MPC Paper No. A/H5/414B
for Consideration by the
Metro Planning Committee
on 13.8.2021

APPLICATION NO. A/H5/414

- Applicant** : Board Profit Limited and Come First Limited represented by Masterplan Limited
- Site** : 33 – 35 Kennedy Road, Wan Chai, Hong Kong
- Site Area** : About 715.7m²
- Lease** : Inland Lot (IL) 1923 S.C ss.1 and IL 1923 S.C ss.2
- Permit for development of European type and design subject to the standard non-offensive trade clause and rate and range clause
- Plan** : Draft Wan Chai Outline Zoning Plan (OZP) No. S/H5/28
- Zoning** : “Residential (Group B)” (“R(B)”)

(b) Minor relaxation of the BH restriction (BHR) may be considered by the Town Planning Board on application under section 16 of the Town Planning Ordinance (the Ordinance)
- Application** : Proposed Minor Relaxation of BHR for Permitted Flat Use

FIG. 4. PUBLIC HOURLY PARKING SPACES WITHIN 300M RADIUS

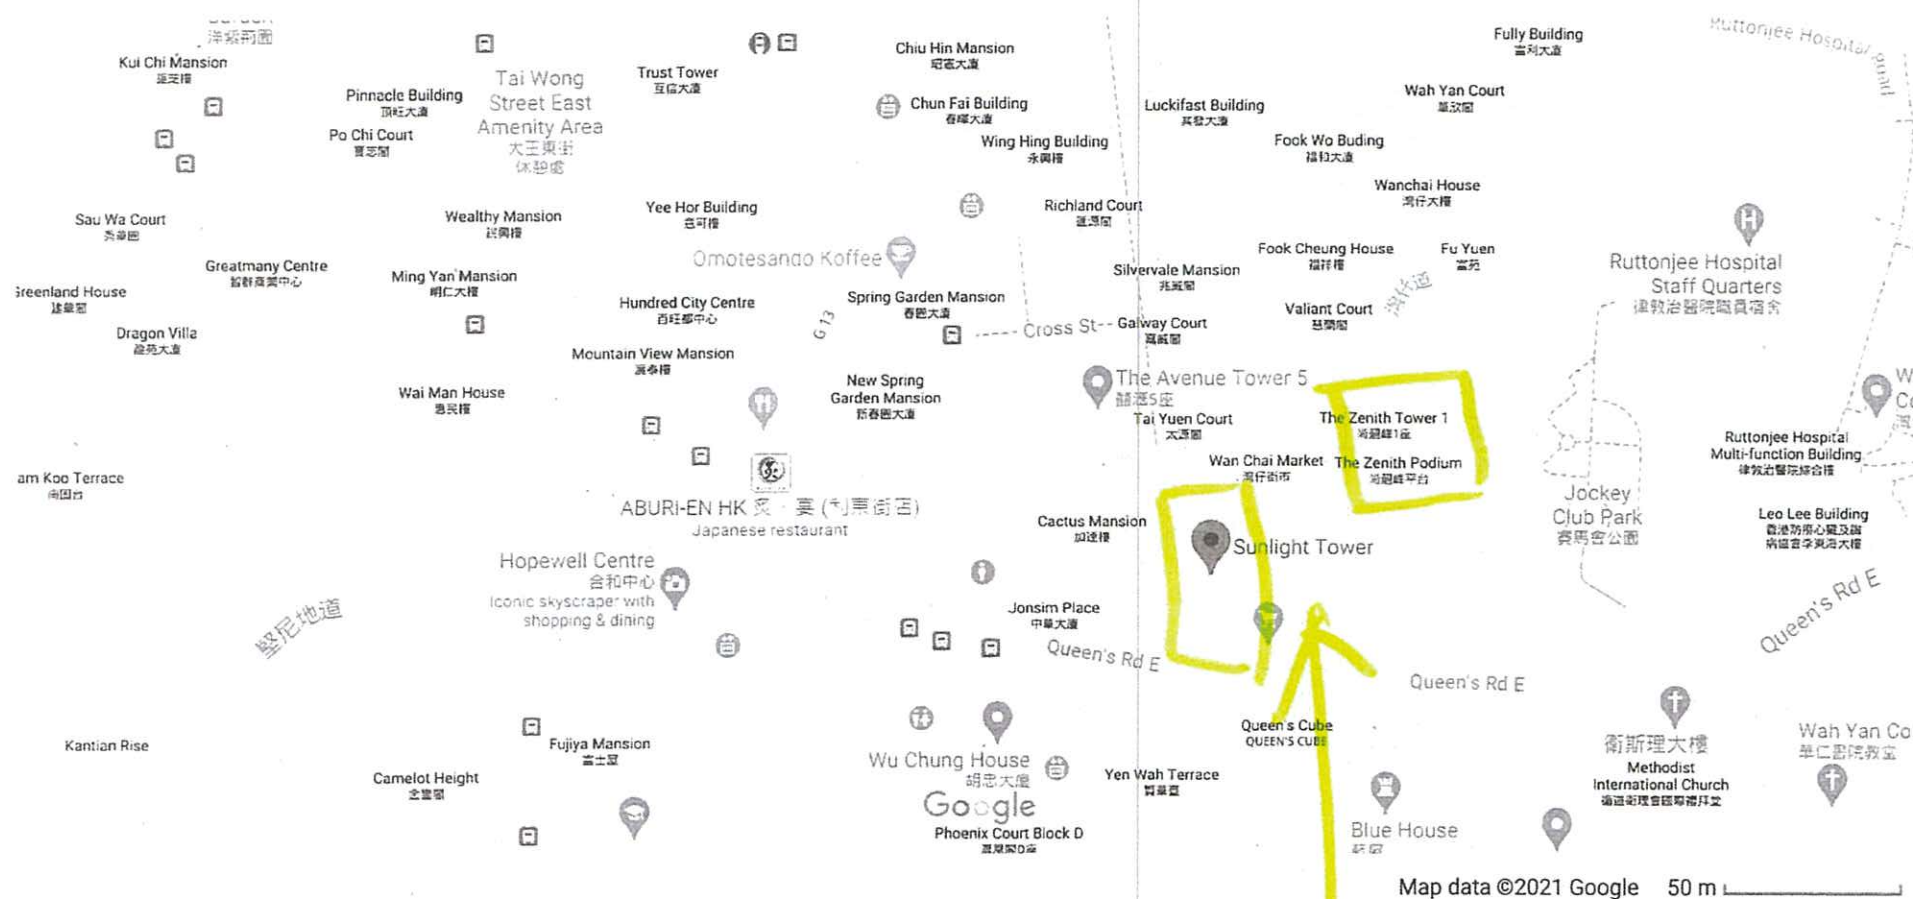
- After a review on the responses to comments made by Transport Department to prepared by the Developer's appointed consultant LLA Consultancy Ltd, we found that in Figure 4 of the response, the marking on the Legend on the location of (4) 248 Queen's Road East and (5) The Zenith were incorrect. Please see copy of figure 4 and copies of the map showing the correct location of (4) and (5). Such mistake made on the report as a response to comments made by Transport Department is unacceptable and unprofessional. As such, the accuracy of other information or founding contained in the response are also questionable.

MASTER LAYOUT PLAN

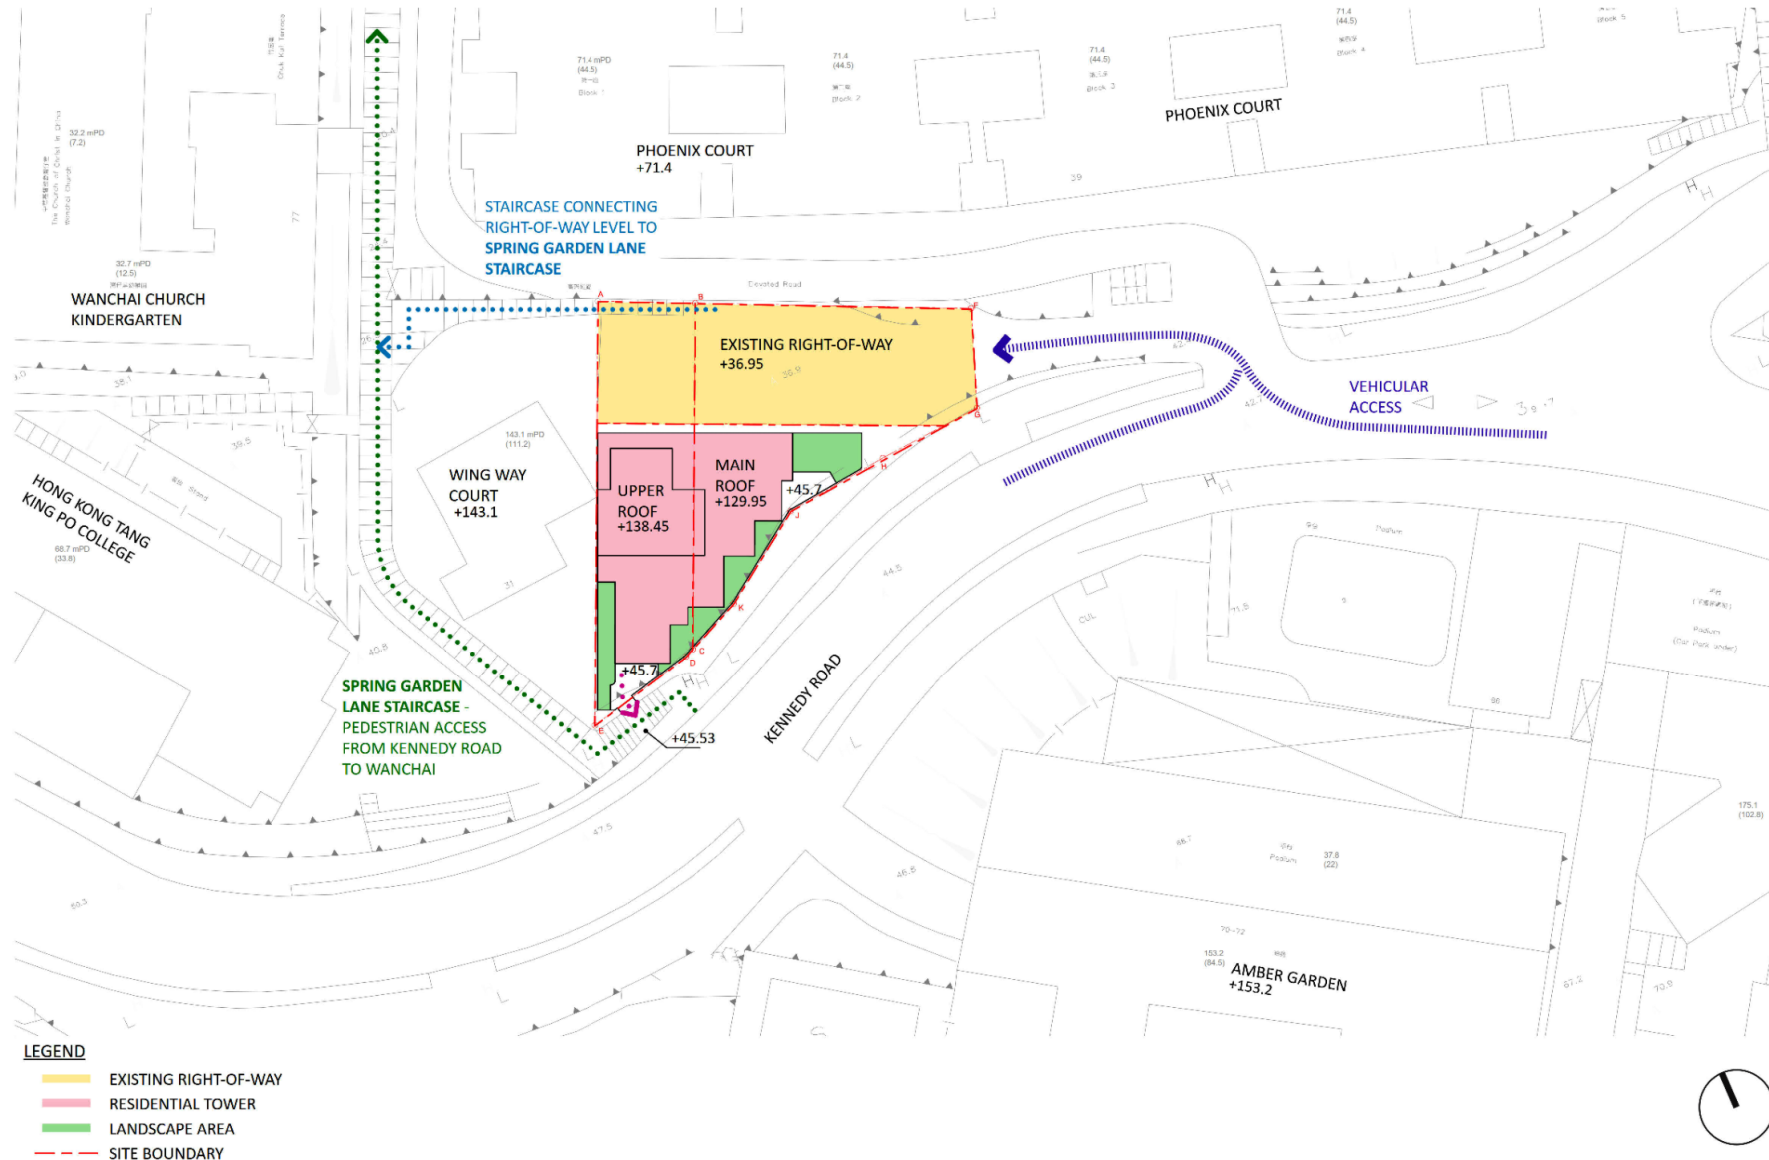
4. **Traffic** - The Master Layout Plan (MLP) shows that NO car-parking is being planned for this redevelopment, and the MLP intimates that the residents of this block will access on foot via Spring Garden. However, these 75 flats will attract considerable traffic (e.g. taxis) along Kennedy Road.

SECTION

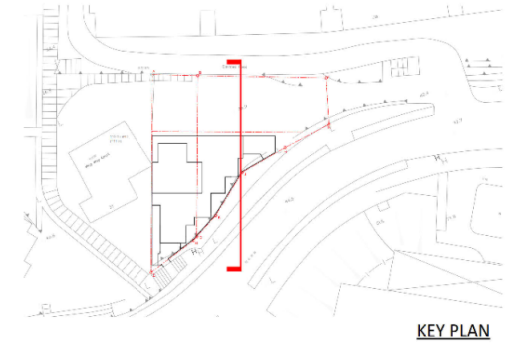
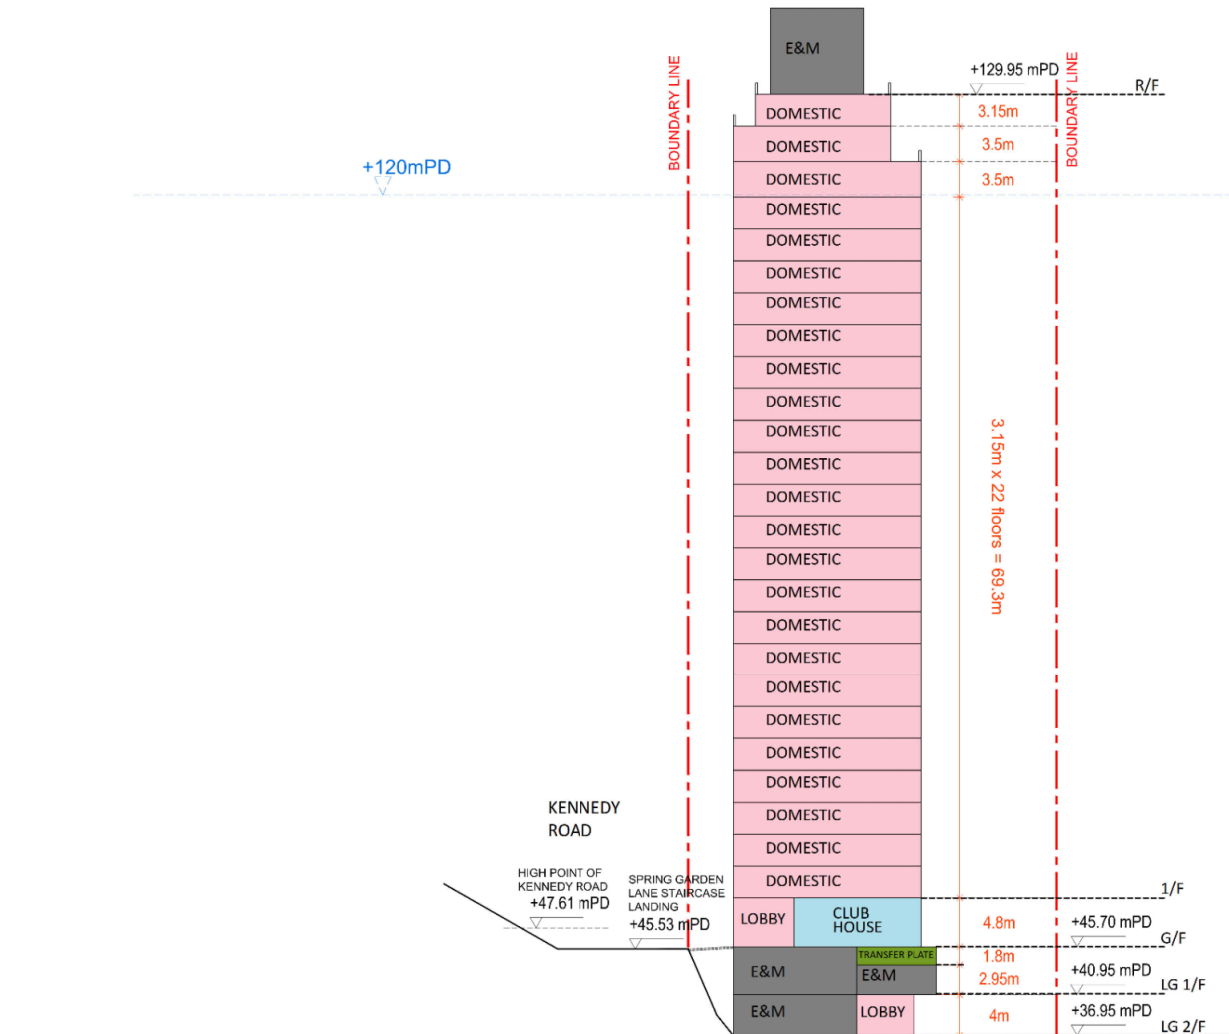
- 1.5 The main uses by floor for the proposed development and floor-to-floor height (**Drawing A-8**) are summarized as follows:

Floor	Main Uses	Floor-to-floor Height
LG 2/F	Lobby, E&M facilities & Disable car park	4m
LG 1/F	Transfer plate & E&M facilities	4.75m
G/F	Lobby & Club House	4.8m
1/F – 25/F	Residential Flats	3.15m (1/F to 22/F) 3.5m (23/F to 24/F) 3.15m (25/F)
R/F	E&M facilities	-
